INDIANA DEPARTMENT OF TRANSPORTATION

AGENDA

March 15, 2018 Standards Committee Meeting

RE: Agenda for the March 15, 2018 Standards Committee Meeting

604-SWCR-14 DETECTABLE WARNING SURFACE DETAILS (WITH MARKUPS)

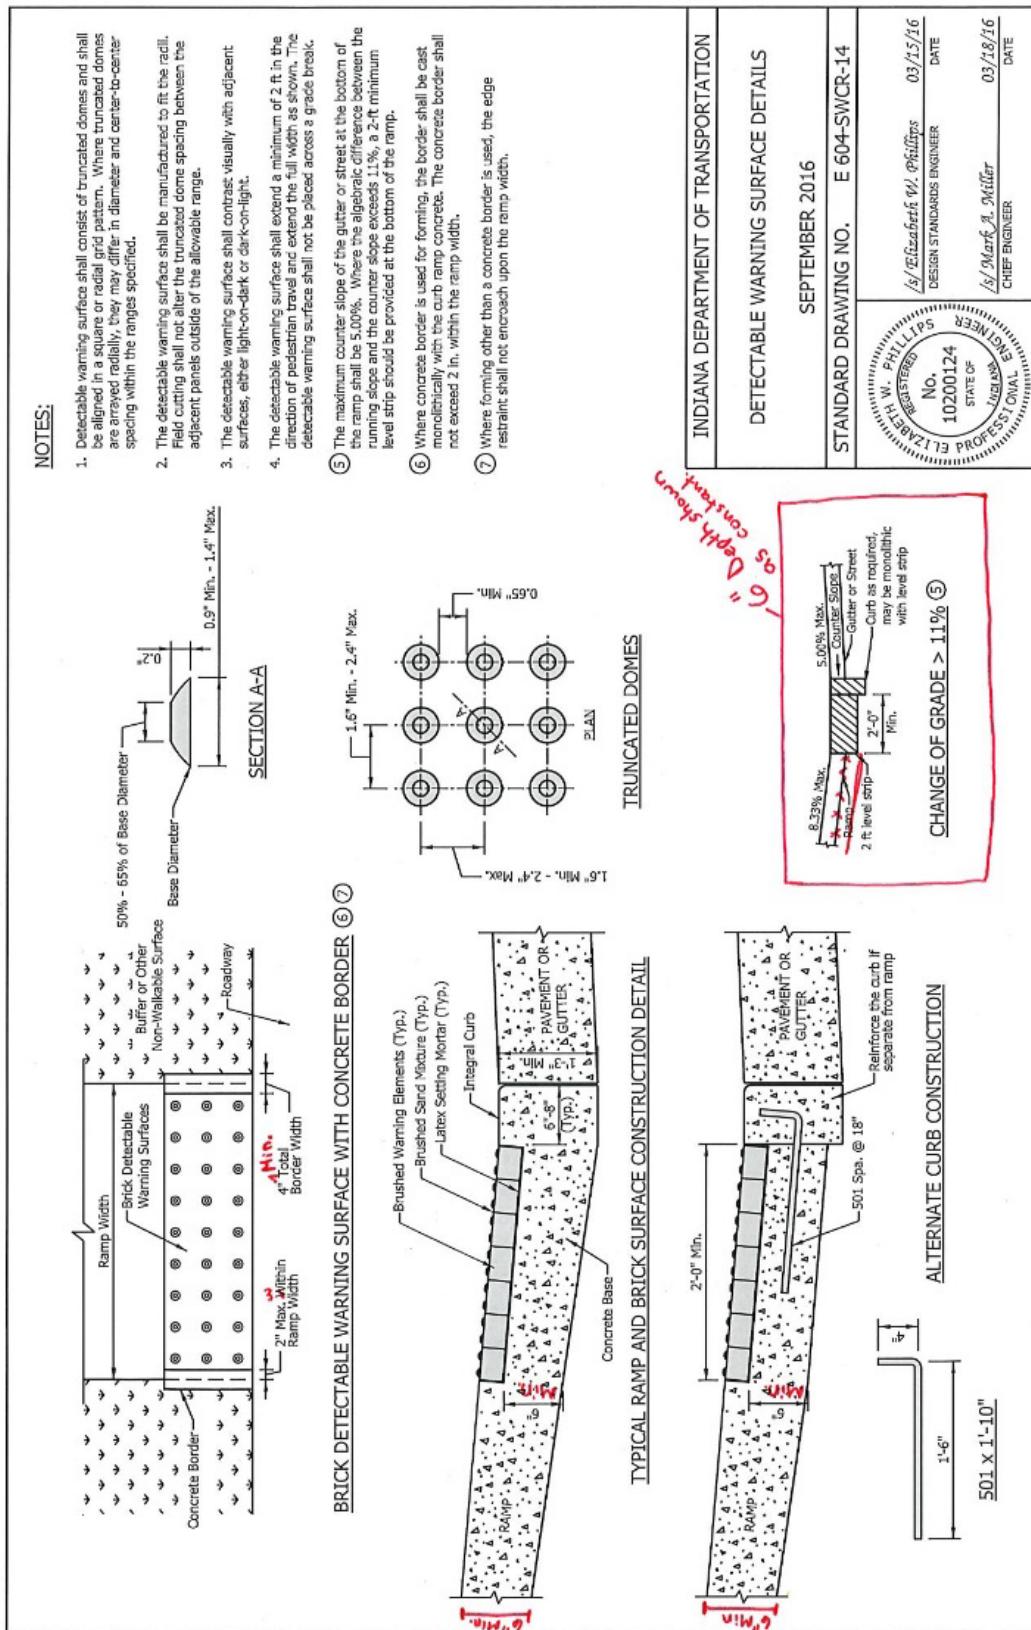
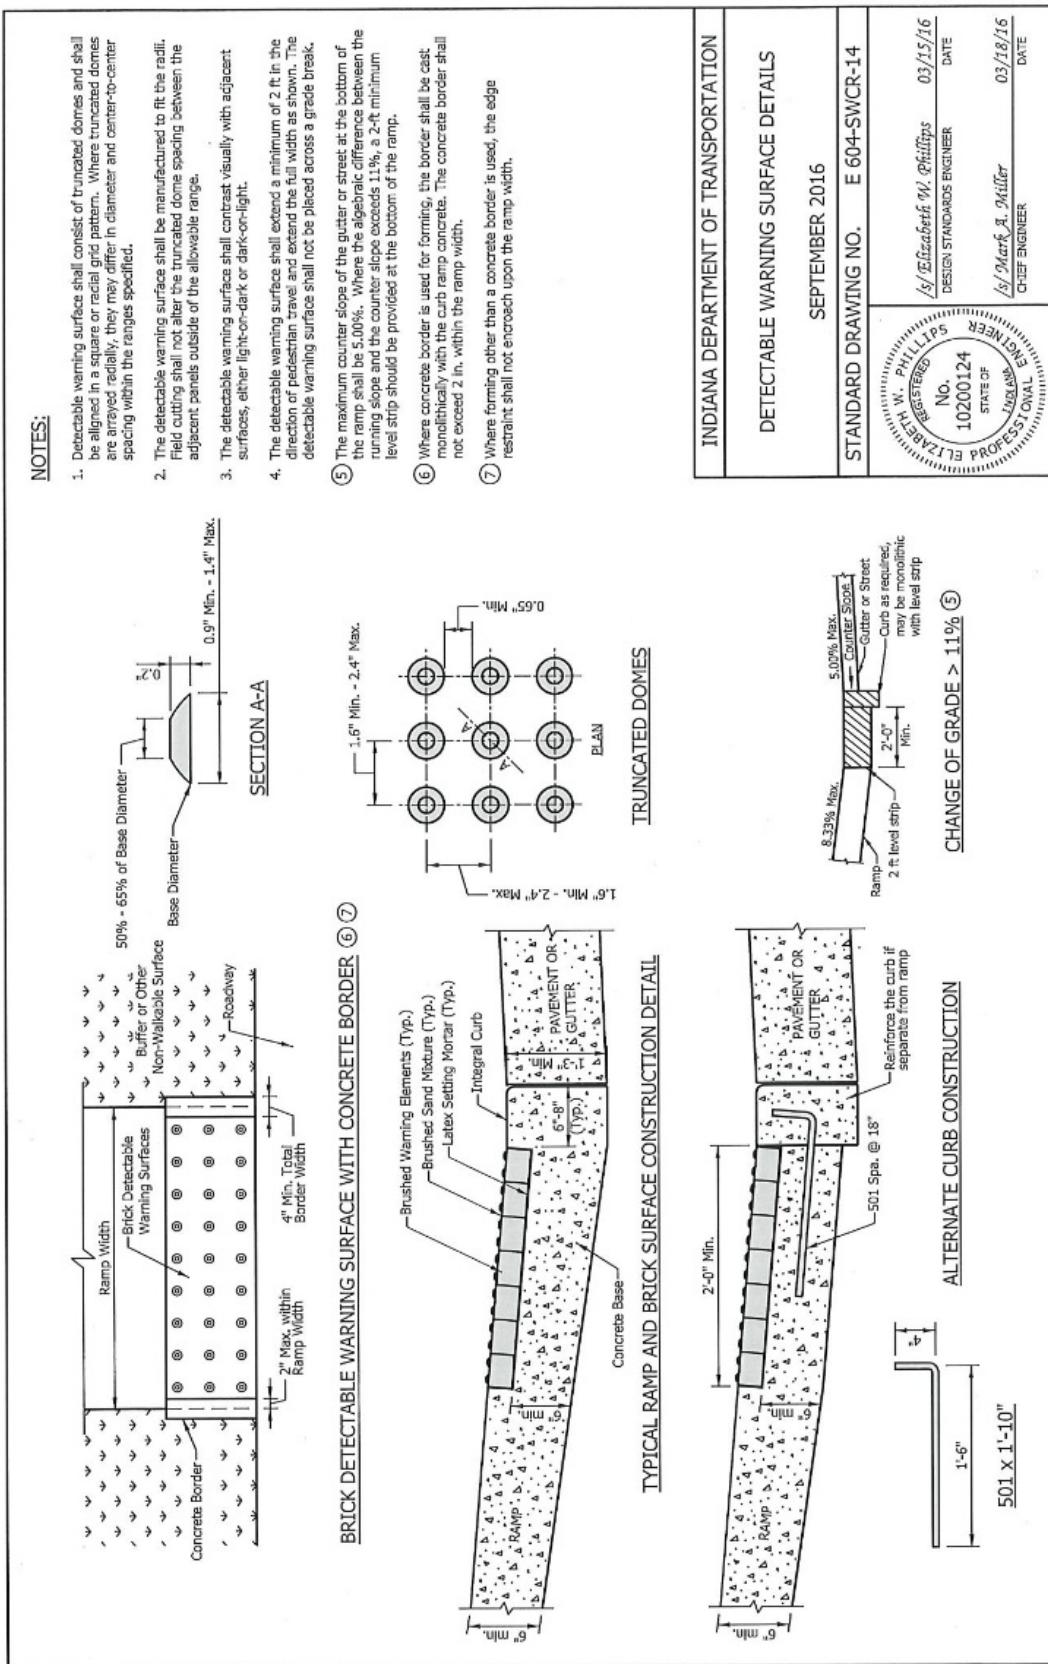
Sheet 14 added a dimension and modified some details to go along with the 6" min. depth for curb ramp components. Minimum was added to the 4" total border width so the contractor did not think the border could only be 4".

622-LSPL-01 PLANTING BALLED AND BURLAPPED TREE (WITH MARKUPS)

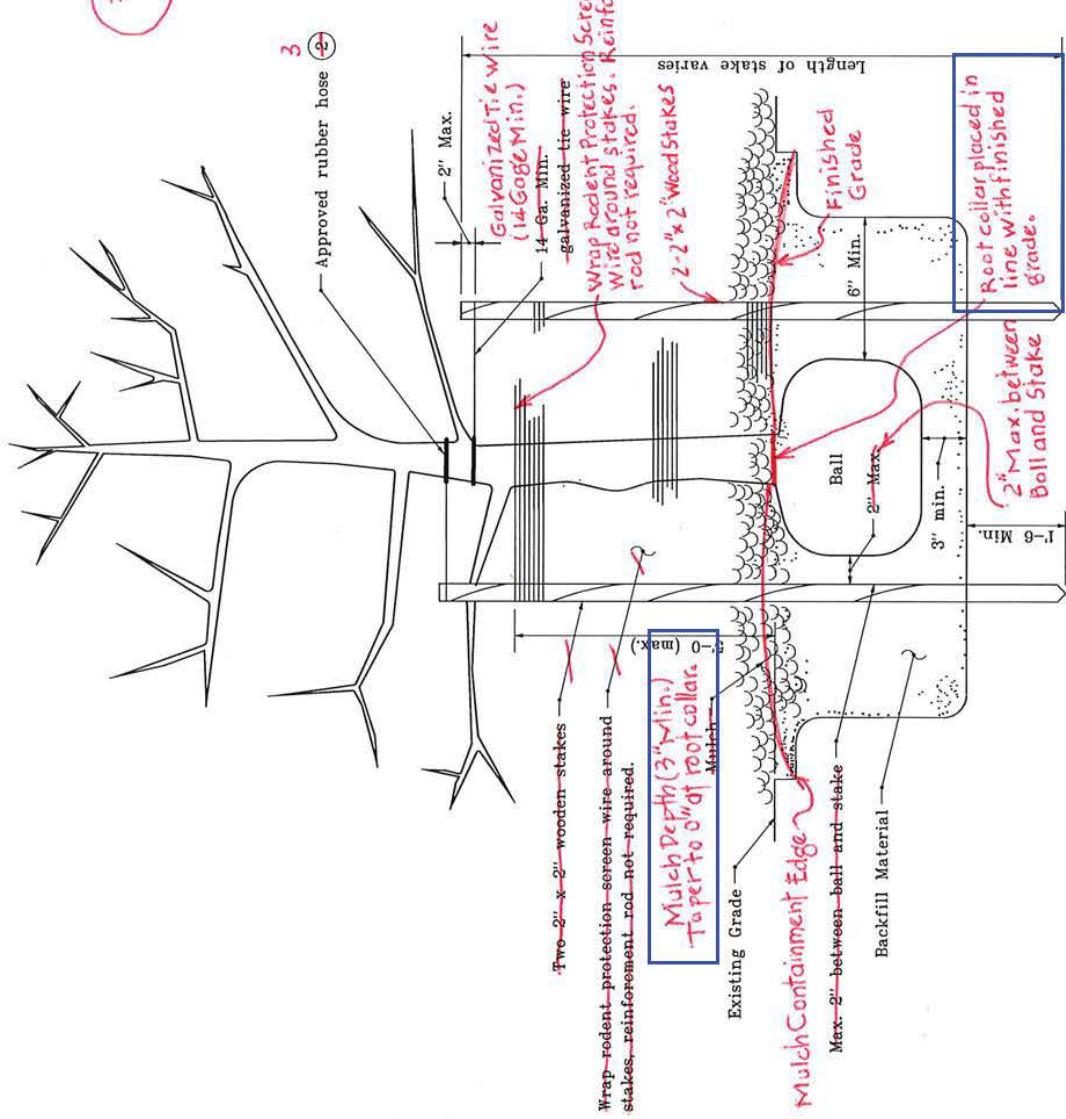
Add Index Sheet E 622-LSPL-00

~~Detail applies to trees less than 1½" caliper.~~
